Maule Aircraft Corporation

NOVEMBER 24, 1965

Service Letter # 10
Model Effected M-4-210
Mandatory on Serial No's 1002, 1003, 1005, 1006, and 1008
thru 1014, 1016, 1017 1019, 1020, 1021 and 1023 thru 1027,
and 1030, 1031 and 1033.
FAA approved

Instruction Sheet
Service Letter # 10

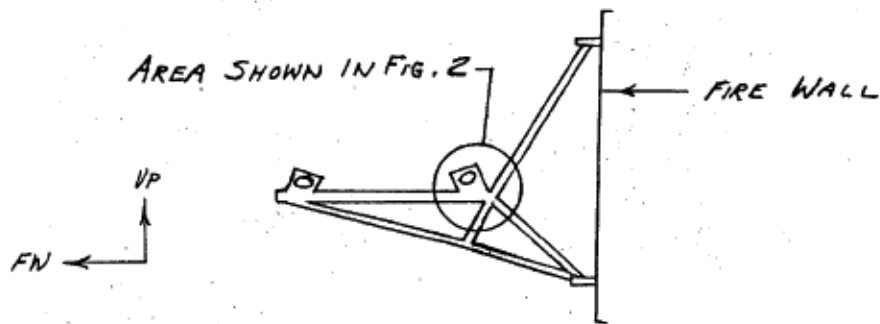
There has been some cracking of the engine mount tubes adjacent to the rear engine mount support fitting. These failures are more prevalent at the right rear support location and were in the tubing around the rear of the bracket.

Please make a visual inspection using at least a 10 power magnifying glass at this point on both sides and if any cracks are found have your aircraft repaired as per the enclosed instructions before flying it.

If no cracks are found inspect before each flight and have the repair made at the earliest possible opportunity.

Please find enclosed reinforcement fitting and installation instructions.
